LEXINGTON-FAYETTE URBAN COUNTY GOVERNMENT CONTRACT CHANGE ORDER Page 1 of 11		Date:	October 1, 2025
To (Contractor):		Project:	Clays Mill Road Improvements, Section 1
L-M Asphalt Partners, Ltd.		Location:	CMR - Waco to Harrodsburg
dba ATS Construction		Contract No.	17-2020
3009 Atkinson Ave, Suite 400, Lexington, KY 40509		Original Contract Amt.	\$10,683,653.39
		Cumulative Amount of Previous Change Orders	\$1,373,272.58
		Percent Change - Previous Change Orders	12.85%
		Total Contract Amount Prior to this Change Order	\$12,056,925.97
		Change Order No.	5 - Final
You are hereby requested to comply with the following changes from the contract plans and specification;			
Current Change Order

LEXINGTON-FAYETTE URBAN COUNTY GOVERNMENT CHANGE ORDER				DATE:		October 1, 2025
				Change Order #:		5 - Final
				CONTRACT #:		17-2020
Project: Clays Mill Road Improvements, Section 1						
You are hereby requested to comply with the following changes from the contract plans and specifications;

**Clays Mill Road Improvements, Section 1
Change Order No.5 - Final
Reasons for Porposed Changes**

PROPOSED TYPICAL DRIVEWAY SECTIONS

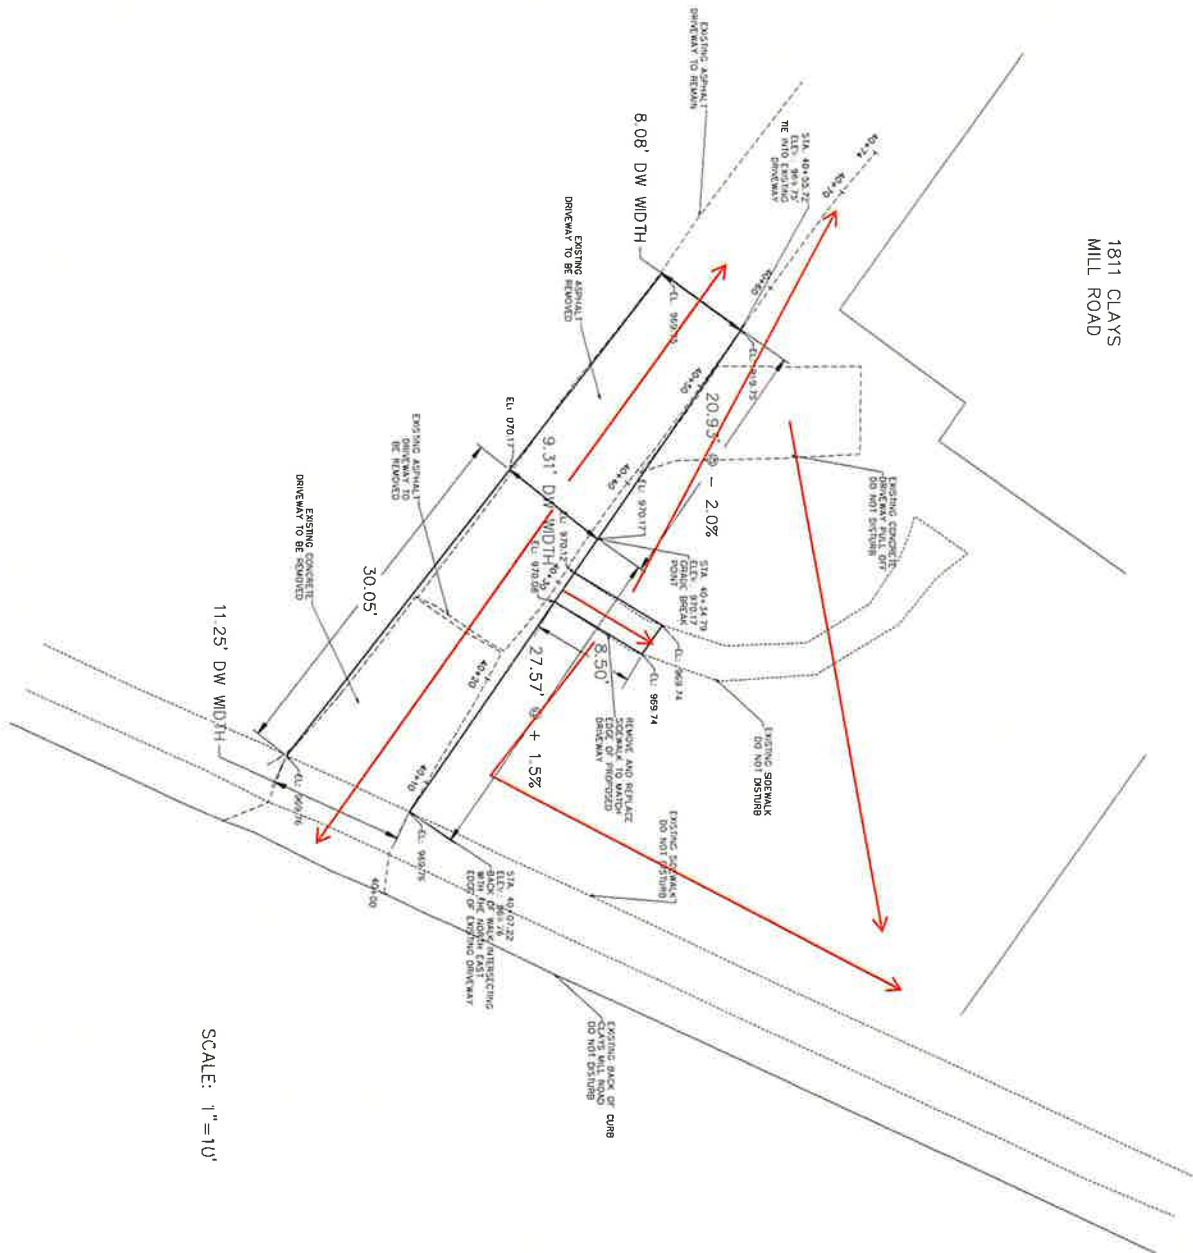
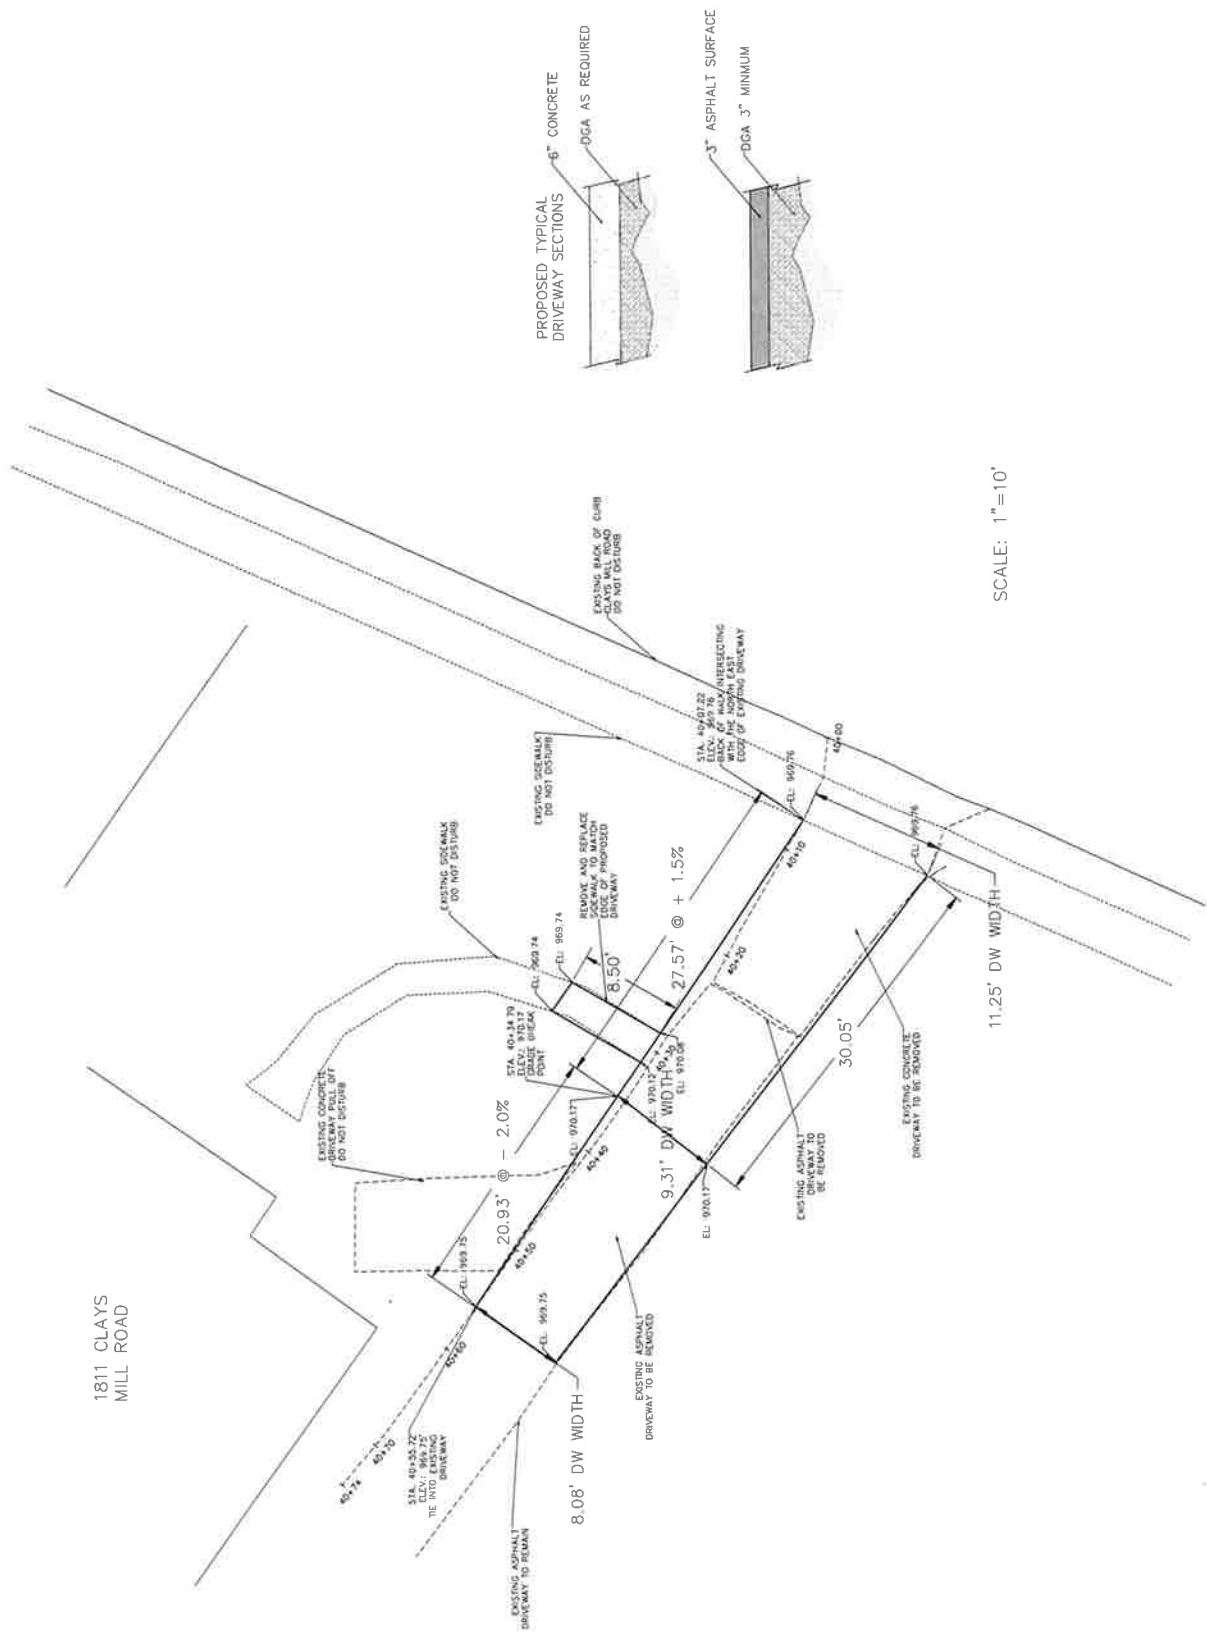
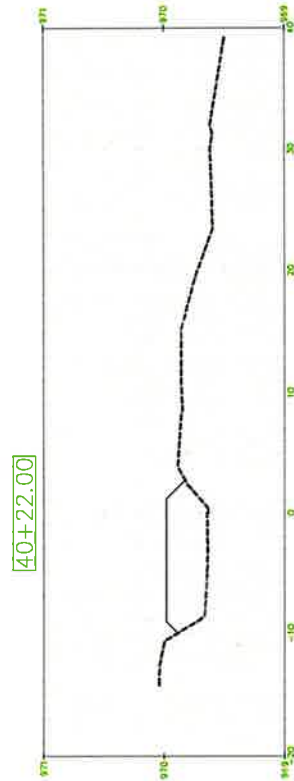
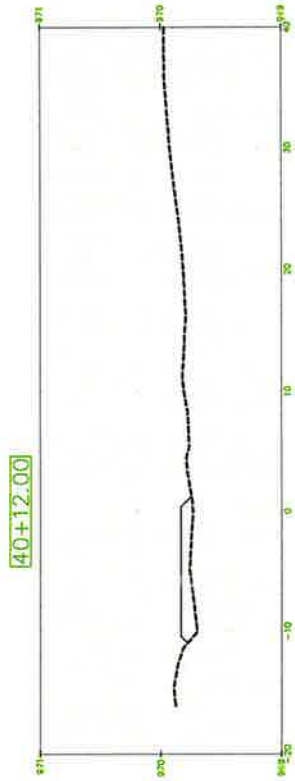
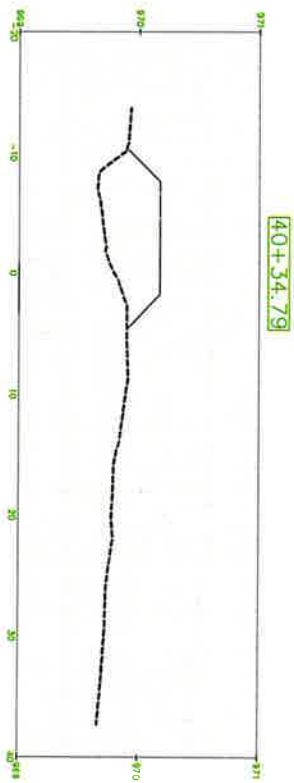
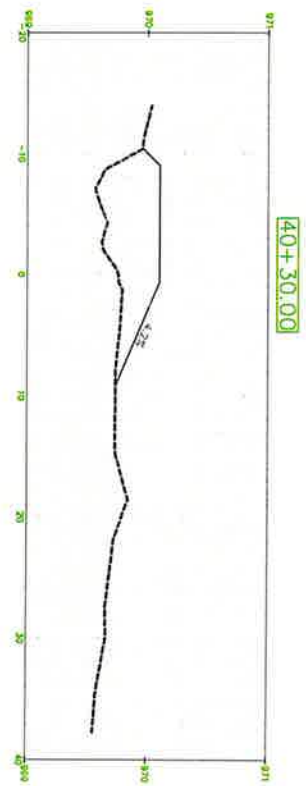
At the request of LFUCG, ATS Construction proposes the following price to remove, regrade, and repave the driveway at 1811 Clays Mill Road per the attached drawing provided by LFUCG.

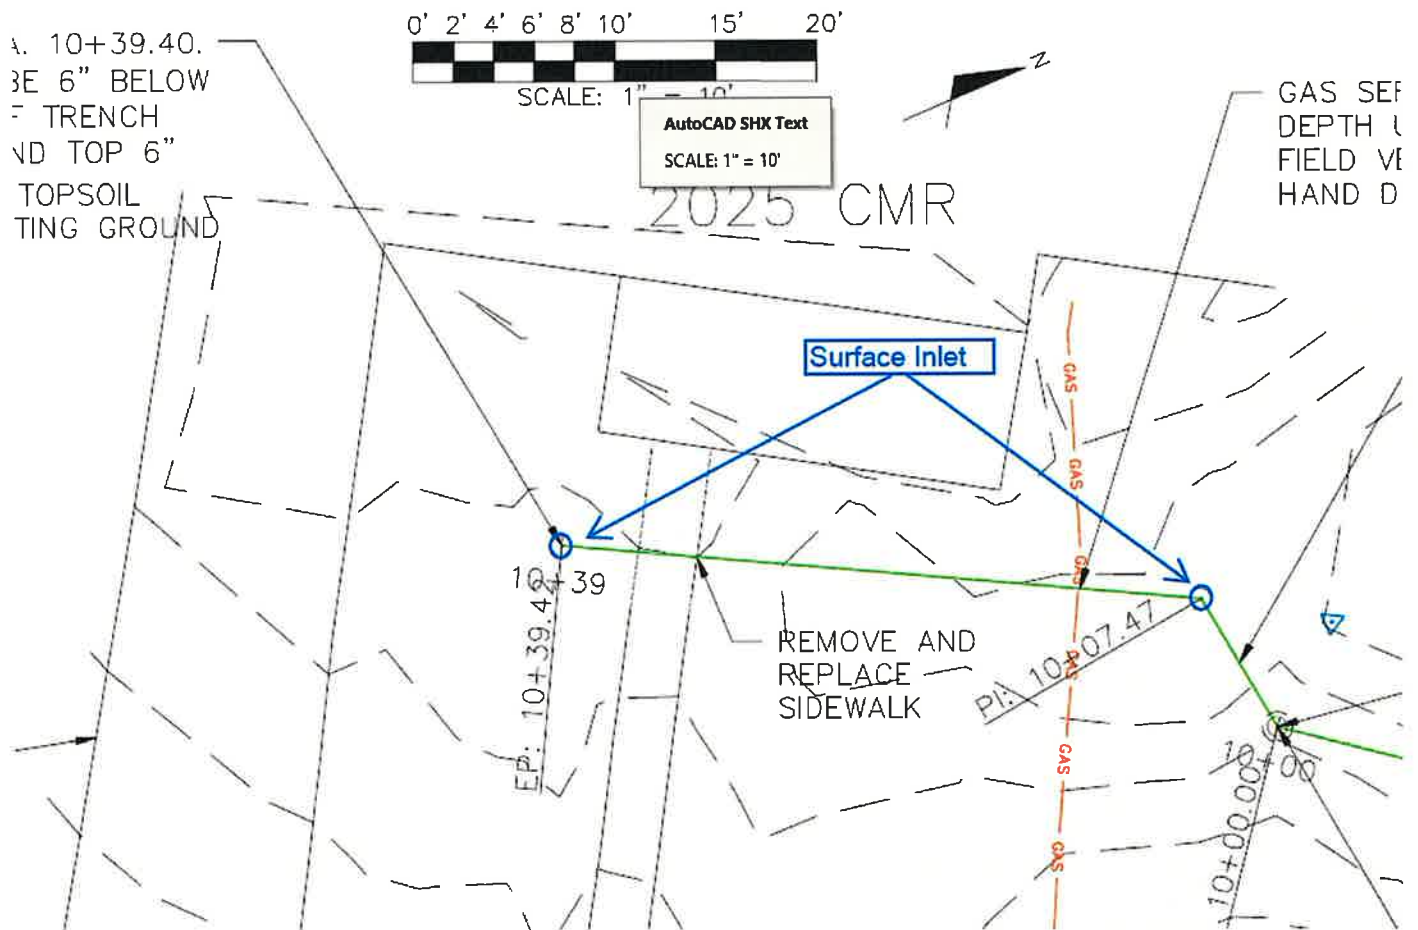
Dylan,
We want to go back to the inlet concept.
